## **Addendum No. 2**

### **Request for Proposals ES-24-02 Engineering Consulting Services - 2024 Well Field Review and Expansion Foothills Boulevard Regional Landfill**

# POLLUTION CONTROL INFRASTRUCTURE FOOTHILLS BOULEVARD REGIONAL LANDFILL

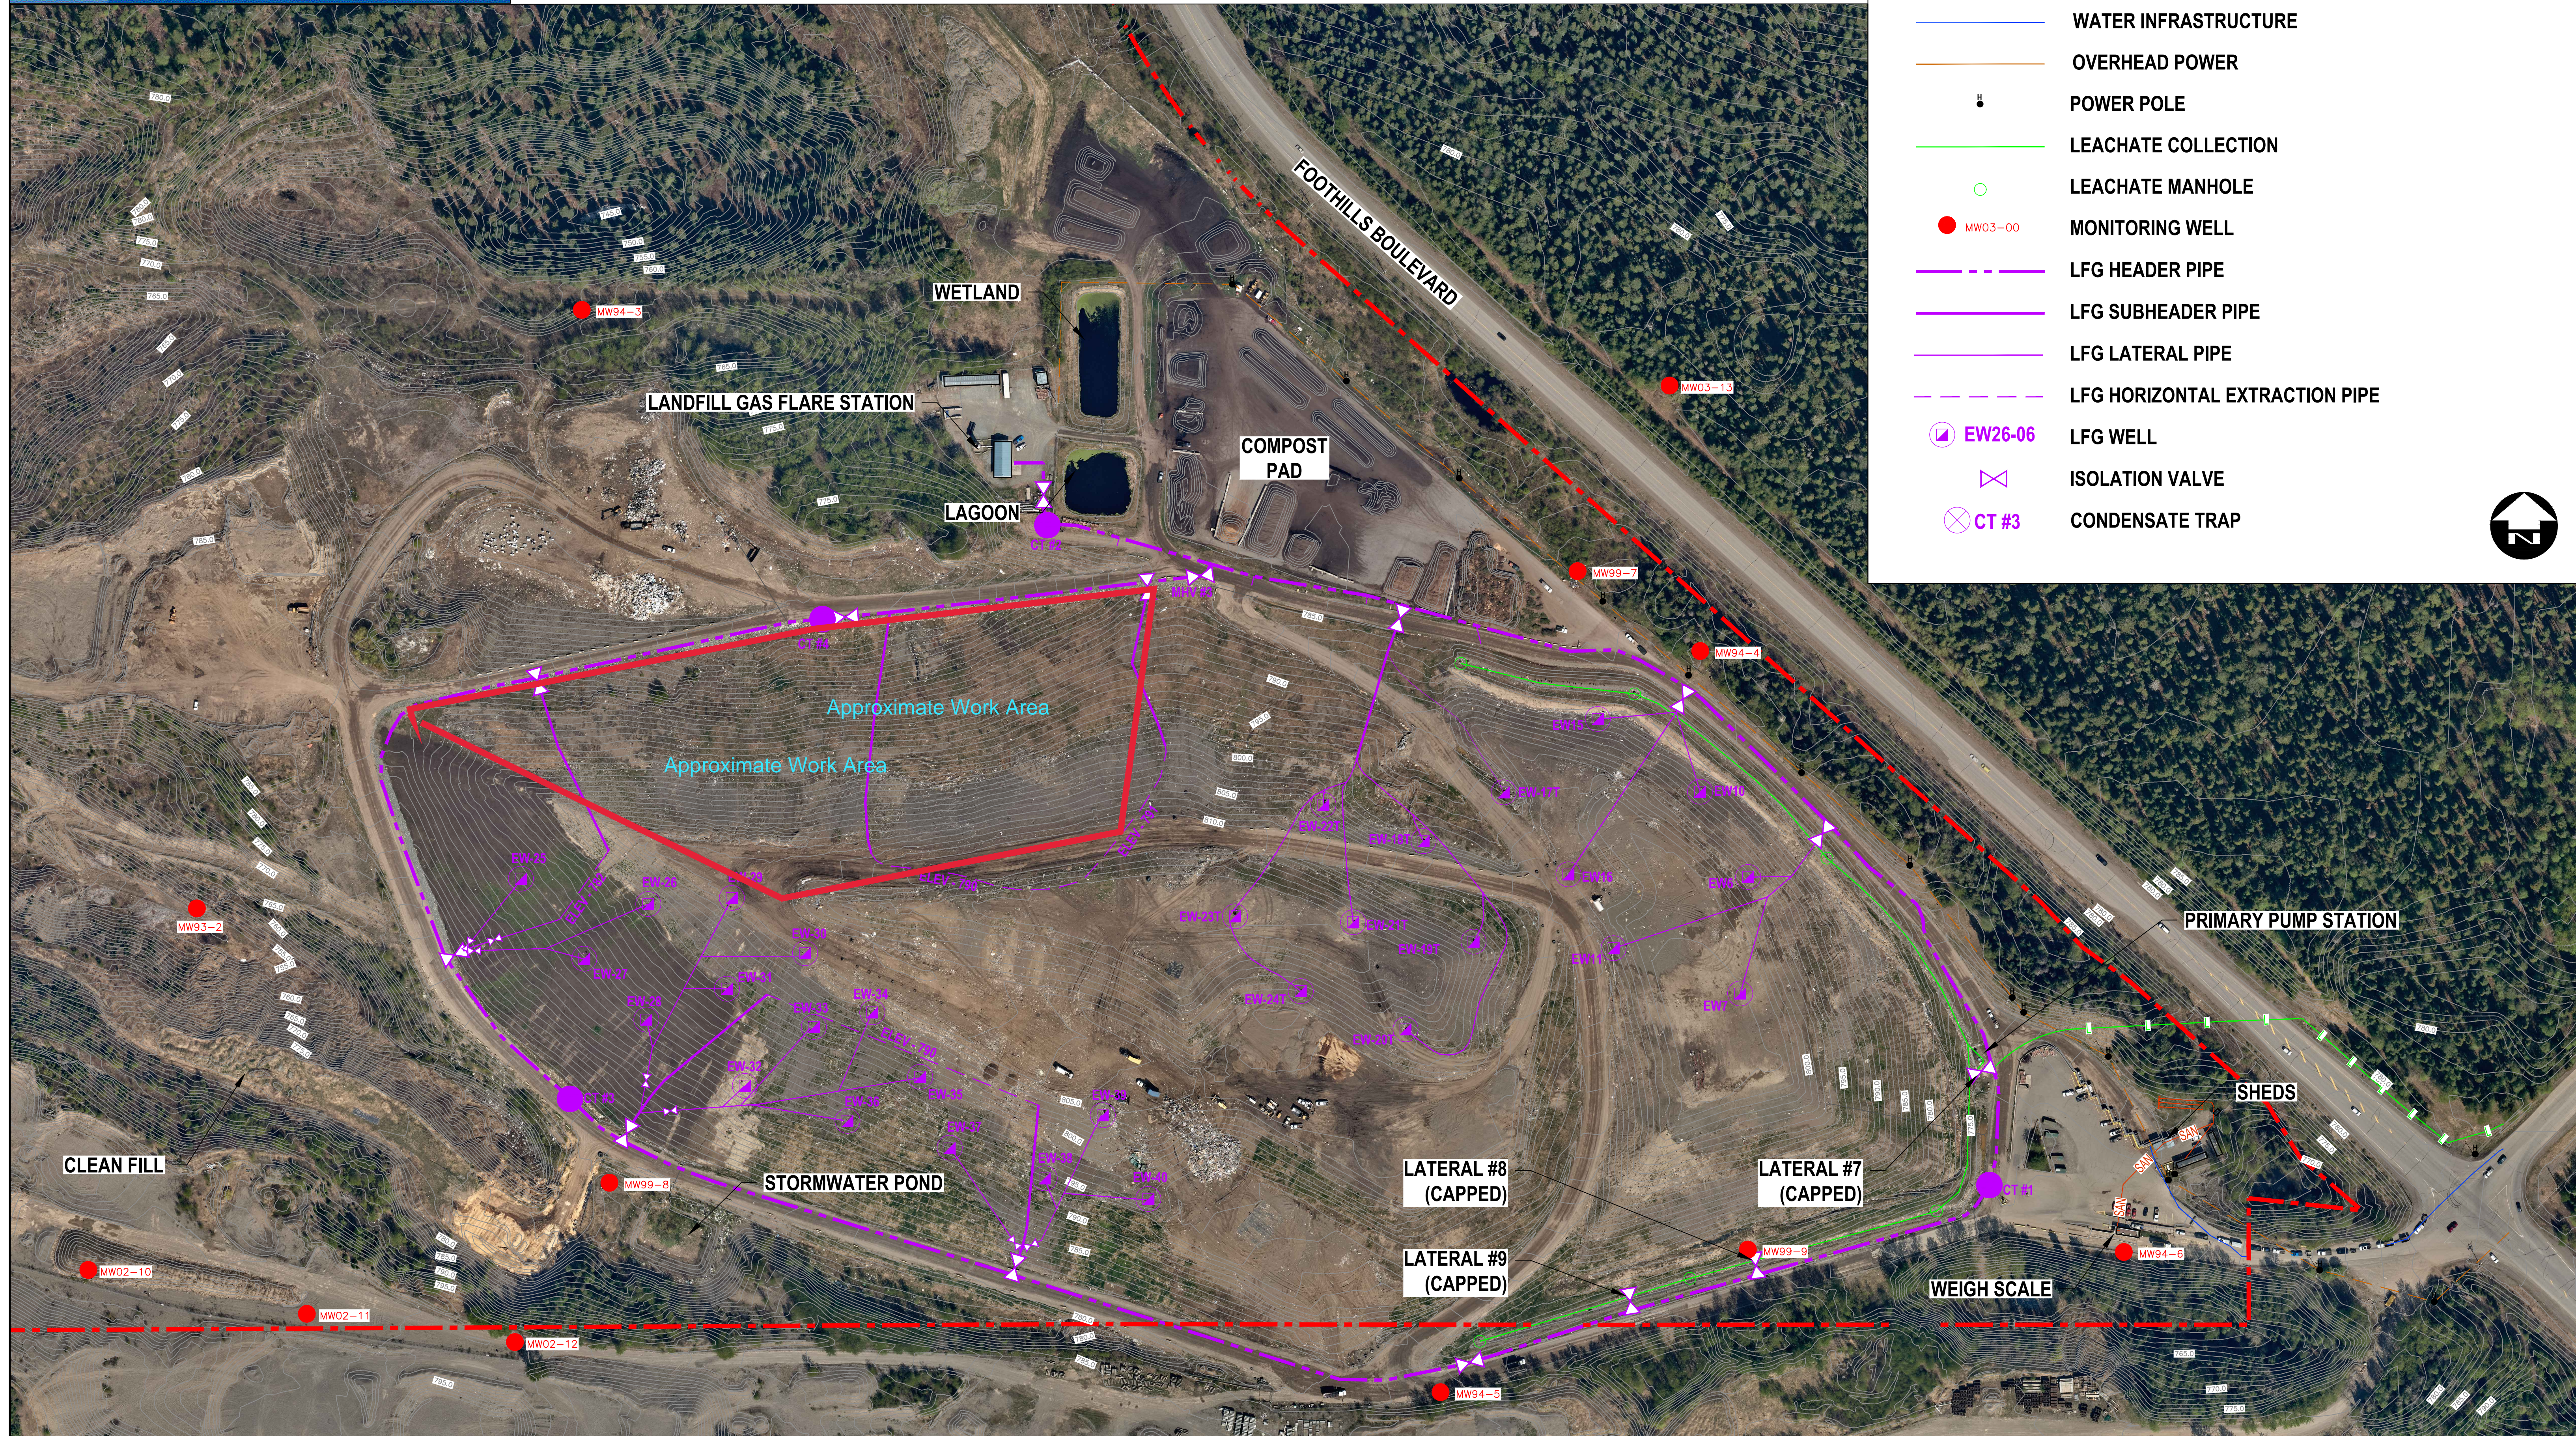
Question 2: Can the RDIFFG provide us with an approximate number of wells that are anticipated to be installed or the size of the area for the 2024 expansion, so we can determine the amount of time required for on-site supervision? This information is also required in order to determine costing for the 2024 landfill gas wellfield expansion detailed design work.

Answer 2: Please find attached. Figures - FOOTHILLS - INFRASTRUCTURE Showing Work Area.
